MCB 5.0 & earlier Control Board
(Board you are replacing)

TCB 6.0 or 6.1 Control Board (New Board)

Turnstile Control Board
Model TCB 6.0/6.1

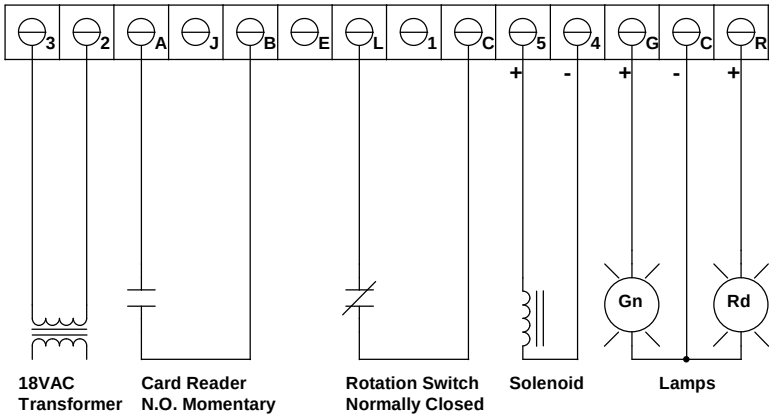
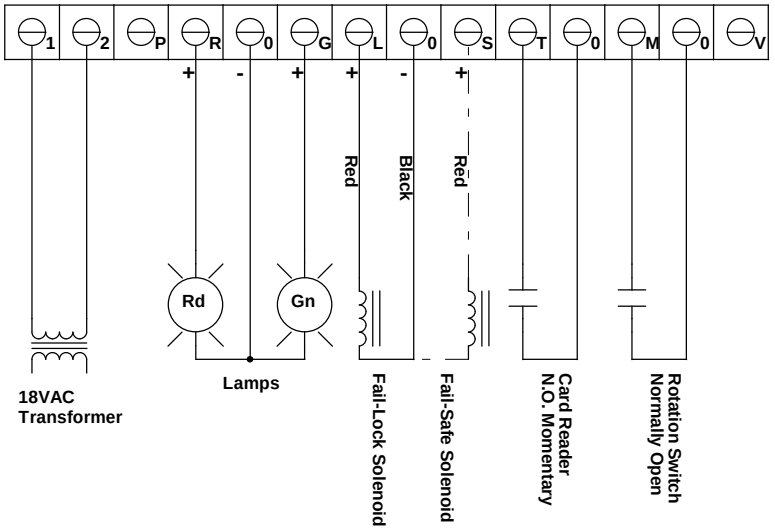
This older/obsolete design required the rotation microswitch to be "Normally Closed"

MCB 3 Thru 5.0	TCB 6.0 – 6.1
18 VAC	3 & 2	1 & 2
Red Lamp	R & C	R & 0
Green Lamp	G & C	G & 0
Card Reader	A & B	T & 0
Rotation Sw.	L & C	M & 0
FL Solenoid	5 & 4	L & 0
FS Solenoid	5 & 4	S & 0

This upgraded Turnstile Control Board has the same mounting footprint as earlier versions. There are no daughter boards nor configuration jumpers. Both "Pulse" and "Timer" features are standard.

Mode configuration is done by wiring the solenoid to the appropriate terminals. For Fail-Lock operation, connect the solenoid to terminals L & 0. For Fail-Safe operation, connect the solenoid to terminals S & 0.

This improved design requires the rotation microswitch to be "Normally Open" You must move the wire currently on the NC terminals of the microswitch to the NO terminals of the microswitch.

IMPORTANT
Move wire on rotation microswitch from NC to NO
